## SYDNEY CENTRAL CITY PLANNING PANEL

### COUNCIL ASSESSMENT REPORT

<b>Panel Reference</b>	PPSSCC-518
<b>DA Number</b>	DA/47/2024
<b>LGA</b>	City of Parramatta Council
<b>Proposed Development</b>	Signalisation/reconfiguration of Kissing Point Road/Bundil Blvd and Victoria Road intersection, reconfiguration of Marsden Road/Wharf Road and Victoria Road intersection, widening/reconfiguration of Victoria Road, and widening/reconfiguration of Wharf Road and Torrens Subdivision (to dedicate roads). This application is to be determined by the Sydney Central City Planning Panel.
<b>Street Address</b>	Lot 4 - 7 DP 1248652 Victoria Road, Melrose Park and 700 Victoria Rd, Ermington (Lot 4, 5, 6 and 7 DP 1248652 and Lot 17A DP 440585)
<b>Applicant</b>	SH Melrose PP Land Pty Limited
<b>Owner</b>	SH Melrose PP Land Pty Limited
<b>Date of DA lodgement</b>	25 January 2024
<b>Number of Submissions</b>	2
<b>Recommendation</b>	Approval
<b>Regional Development Criteria</b>	Pursuant to Clause 2 of Schedule 6 of State Environmental Planning Policy (Planning Systems) 2021, the development has a capital investment value of more than \$30 million.

**Figure 17 - Map showing proposed extended no stopping zones**

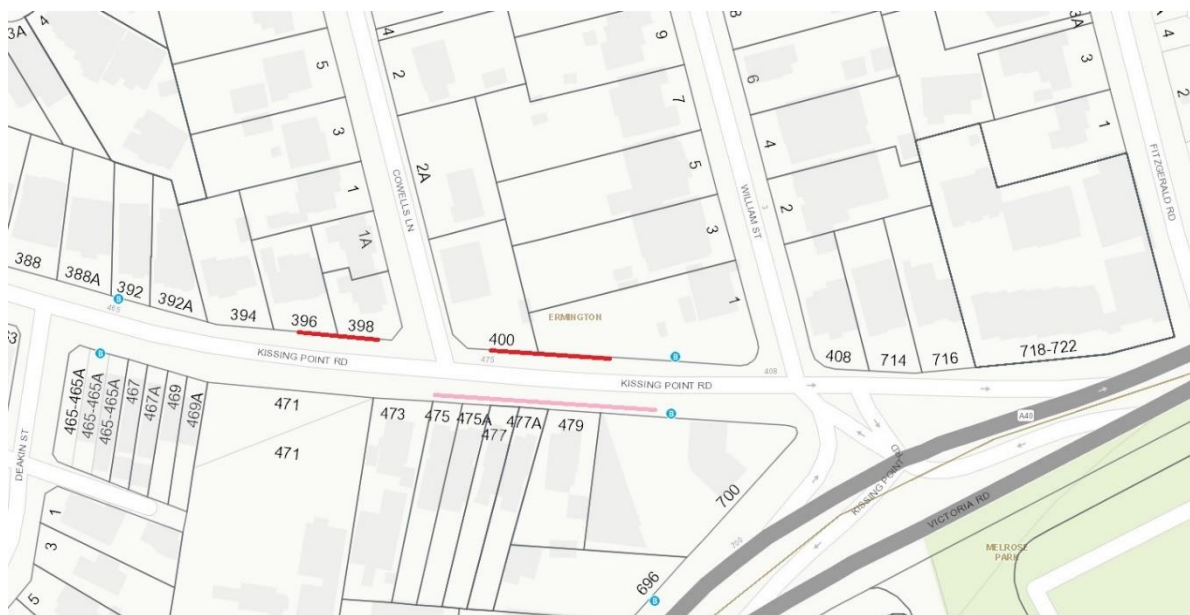
The plans are indicating an extension to the no stopping zones along Kissing Point Rd which will lead to the removal of some on-street parking.

- Southern Side (removal of 5 spaces, shown as a pink line in Figure 16 below) – This is to allow for the extension of the dual through lanes from the Victoria Rd intersection and merging of northbound lanes.
- Northern side (removal of ~10 spaces, shown as red lines in Figure 16 below)- This is proposed due to the decreased lane width being 5m to accommodate the dual through lanes in the other direction.

At this stage the proposed extension of the no stopping zones along Kissing Point Road will be subject included in the TfNSW WAD scope of works. If this changes in the future the proposed no stopping zones will be subject to approval by the Parramatta Traffic Committee.
